<div>CASE # 2014-COA-295 (WP)</div>	<div>INDIANAPOLIS HISTORIC PRESERVATION COMMISSION STAFF REPORT</div>	<div>Hearing Date AUGUST 6, 2014</div>
<div>674 Woodruff Place East Drive WOODRUFF PLACE</div>		<div>NEW CASE</div> <div>Center Township Council District: 16 Brian Mahern</div>
<div>Applicant: TYLER ROSEN mailing address: 674 Woodruff Place East Drive Indianapolis, IN 46228</div>		
<div>Owner: Same as above</div>		
<div>NEW CASE</div>		
<div>IHPC COA: 2014-COA-295 (WP)<ul style="list-style-type: none">Remove enclosed rear porchConstruct 17 ft. x 10 ft. addition</div>		
<div>STAFF RECOMMENDATION: Approval</div>

2014-COA-295 (WP):

Rear View (enclosed porch to be removed)

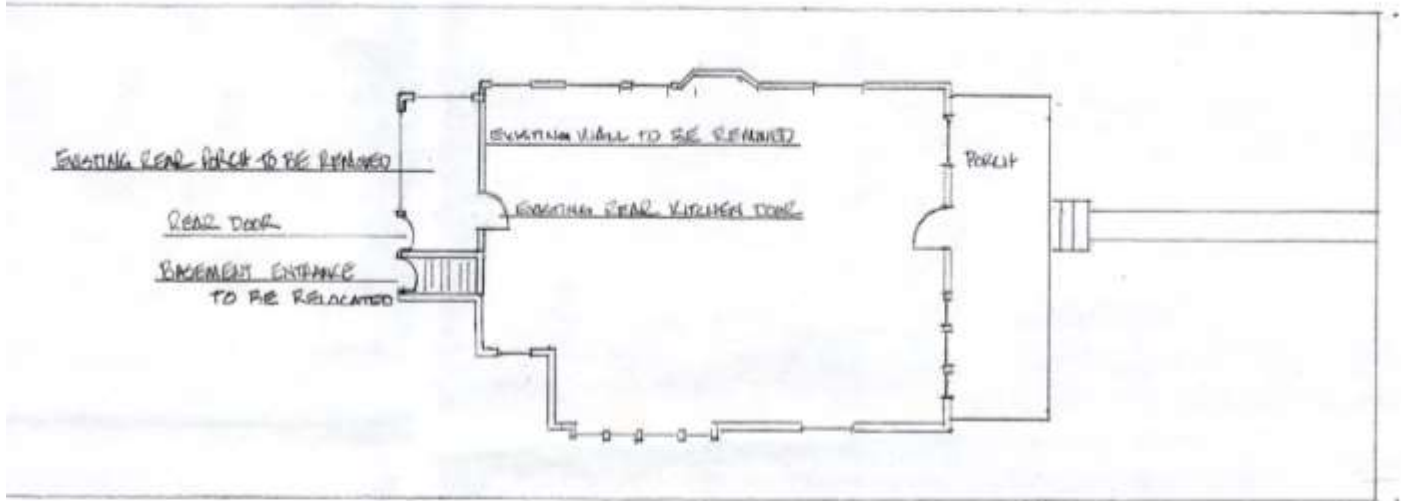
Sanborn maps indicate that this enclosure was originally an open porch. It is unknown when the porch was enclosed, but it was probably over 50 years ago. The enclosure has asbestos siding, bead board siding and wood windows and doors. Its design is typical of early 20th century porch enclosures, and was not uniquely designed to match the architecture of the house. Staff finds its architectural merit to be marginal and its loss to have little effect on the character of the house. An addition will allow an expansion of the kitchen, which will help make this house attractive for future preservation.

Staff believes the simple design of this addition is appropriate for this historic home. Its placement and massing delineate it as a later addition. Staff believes that either wood or fiber-cement in an appropriate lap width is appropriate in this context. The alternative material will not be replacing historic wood siding, and can help further differentiate it from the original house. Staff is still working with the owner to refine some details of the design. Any changes will be described at the hearing.

PROPOSED ADDITION

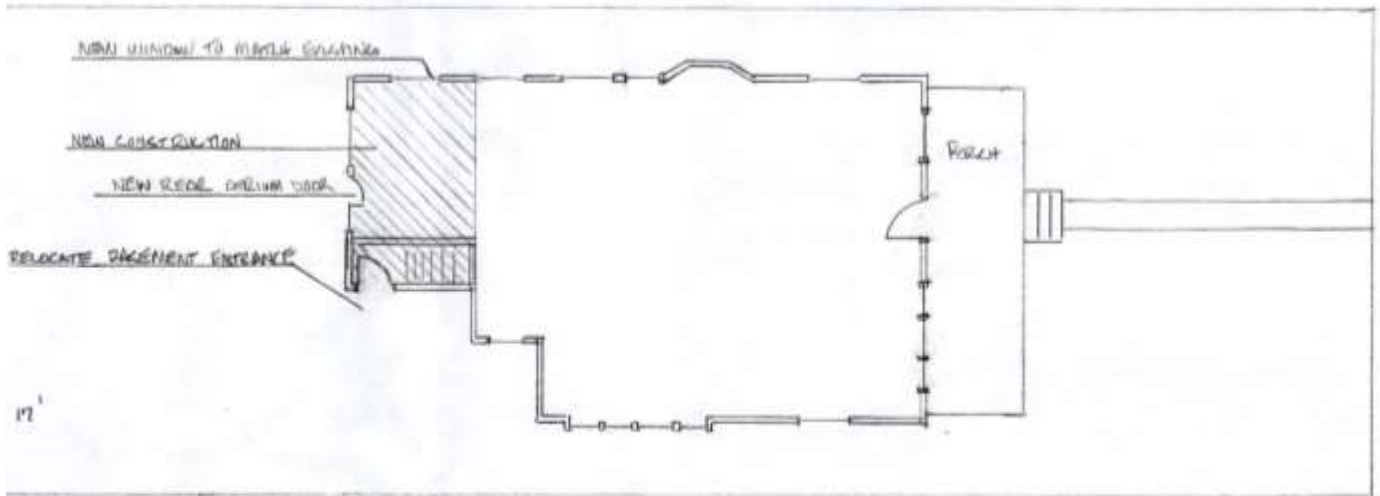
The footprint of the new addition is very similar to that of the existing porch. It will serve as part of the kitchen. The basement access will be relocated to the south elevation of the new addition. The roof is hipped to match that of the main house. The windows and trim will also match those adjacent on the first floor. It is raised up level with the original foundation. Smooth face CMU will be used for the addition foundation. The owners propose using wood or smooth-finish fiber-cement lap siding on the addition.
